211-T PAD
ADDENDUM H
CLOSURE PLAN

Modification History Table

Modification Date	Modification Number
12/06/2021	8C.2021.1F

ADDENDUM H
CLOSURE PLAN

Figure H-5 211-T Pad Sampling Locations

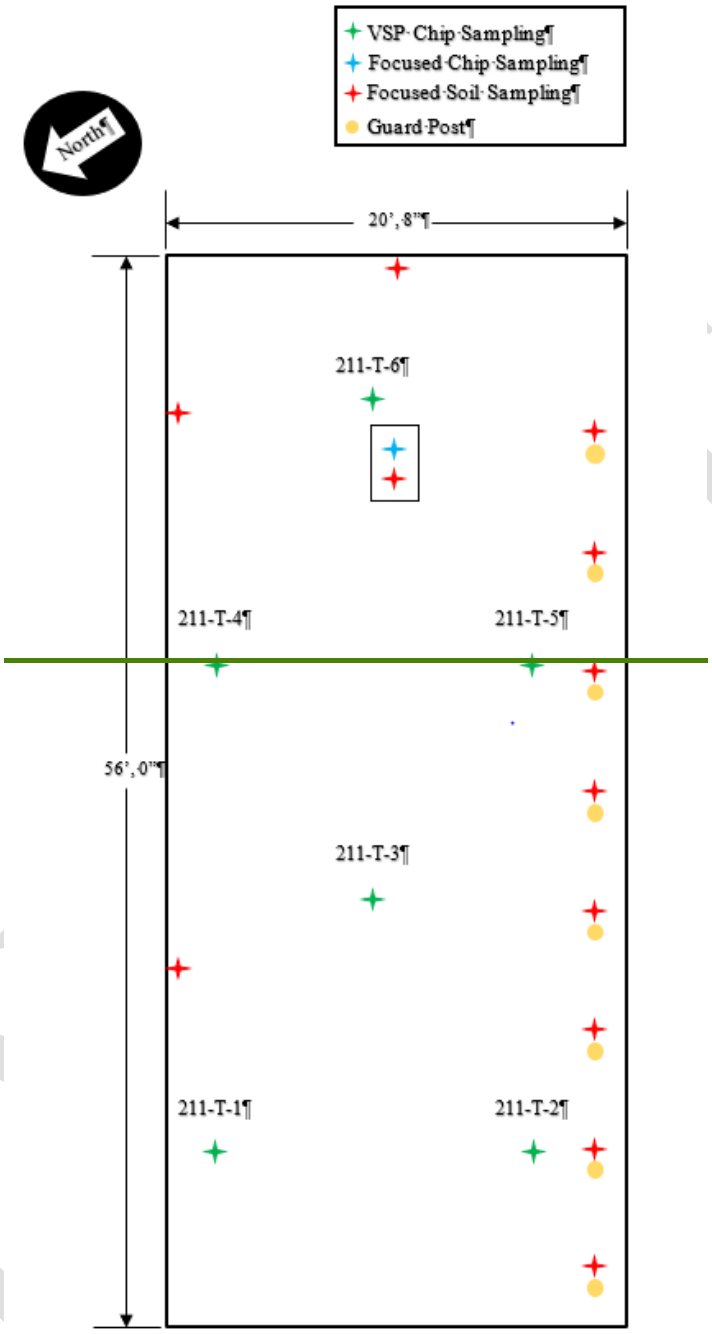
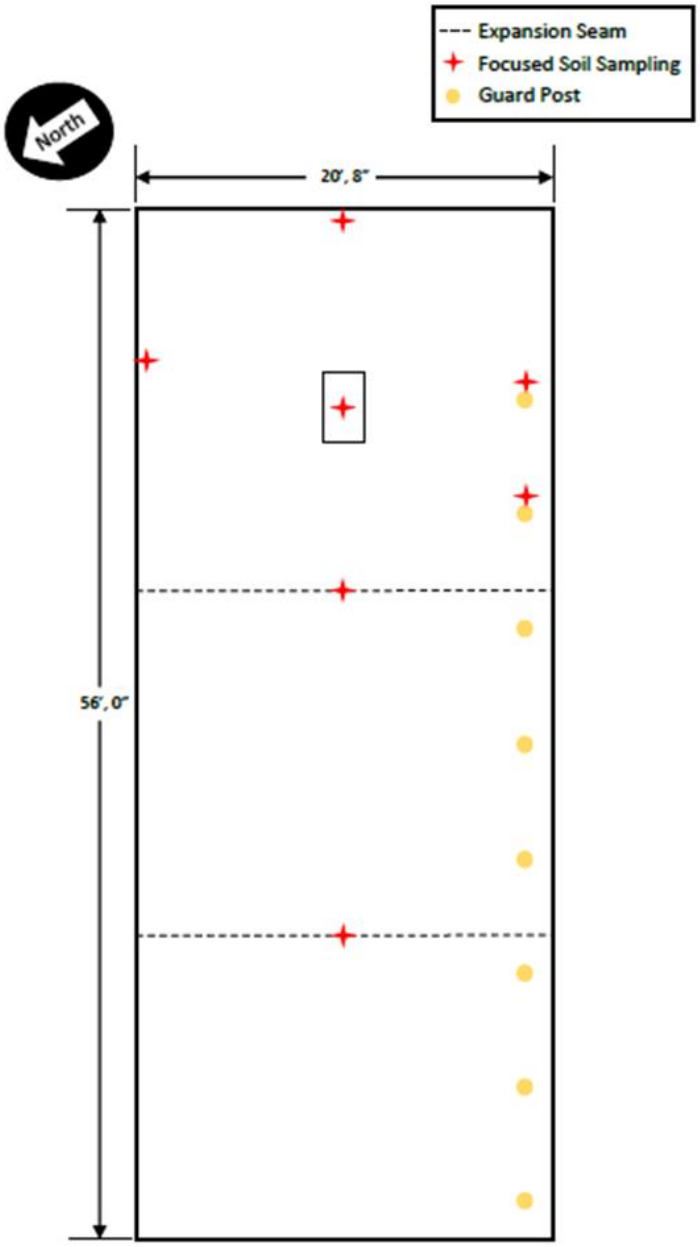
Per the visual inspections (Section H.3.2) and Ecology's professional judgment, ~~twelve~~ seven focused soil sample locations ~~and one focused concrete chip sample location~~ are identified. Identified are ~~eight~~ two guard post soil samples, ~~three~~ four cold joint soil samples, and one blind sump soil sample ~~. One focused concrete chip sample is identified for the blind sump~~ (Figure H-5).

~~Concrete chip samples are collected at regularly-spaced intervals over an area. An initial location or time is chosen at random, and then the remaining sampling locations are defined so the locations are at regular intervals over an area (grid). The Visual Sample Plan (VSP[1]) software was used to create a systematic triangular grid layout with a random starting point. Sample locations were determined using a non-statistical sampling approach with a predetermined number of samples.~~

~~Professional judgment determined that six chip samples would provide sufficient coverage to demonstrate successful decontamination (Figure H-5). Samples will be taken from the node locations indicated by the VSP software and will be assigned sample location identifications and sample numbers using the HEIS database.~~

Sampling and analysis of the 211-T Pad ~~concrete and~~ underlying soil will be conducted to confirm whether closure performance standards have been met. Sampling includes ~~twelve~~ seven focused soil samples~~, one focused concrete chip sample, and six non-statistical grid concrete chip samples~~ (Figure H-5). Sampling and analysis will be performed in accordance with the sampling and quality standards established in this closure SAP.

~~ATTACHMENT B~~
~~T PLANT COMPLEX 211-T PAD~~
~~VISUAL SAMPLE PLAN SUPPORTING DOCUMENTATION~~

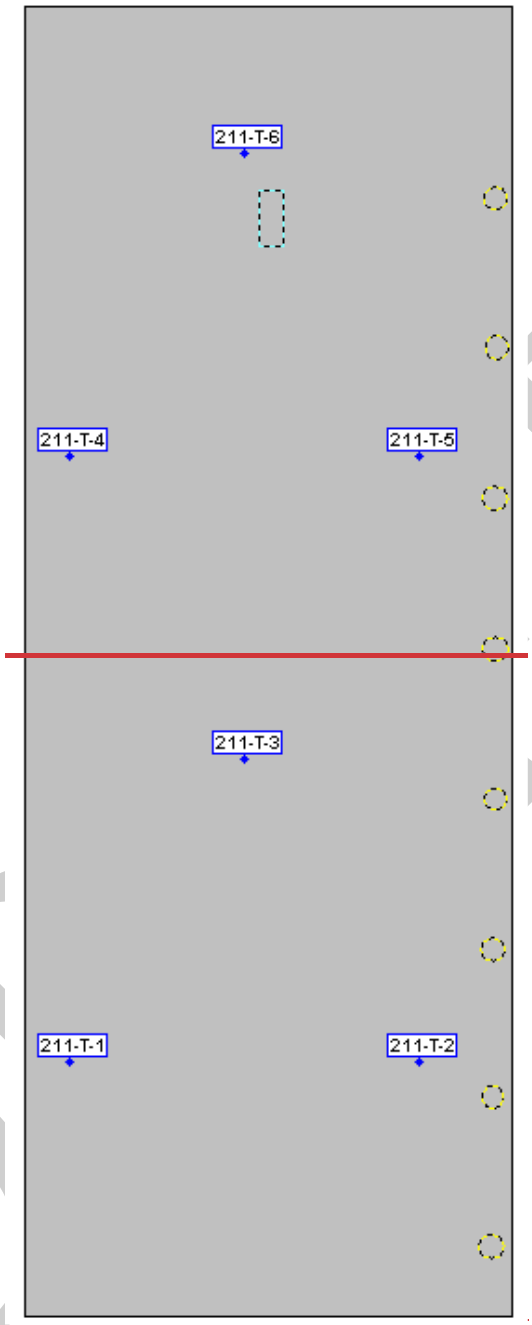
~~North Corner (0, 0)~~

~~Area: Area 1~~						
~~X Coord~~	~~Y Coord~~	~~Label~~	~~Value~~	~~Type~~	~~Historical~~	~~Sample Area~~
~~1.8746~~	~~10.8697~~	~~211-T-1~~		~~Systematic~~		
~~16.8468~~	~~10.8697~~	~~211-T-2~~		~~Systematic~~		
~~9.3607~~	~~23.8360~~	~~211-T-3~~		~~Systematic~~		
~~1.8746~~	~~36.8023~~	~~211-T-4~~		~~Systematic~~		
~~16.8468~~	~~36.8023~~	~~211-T-5~~		~~Systematic~~		
~~9.3607~~	~~49.7686~~	~~211-T-6~~		~~Systematic~~
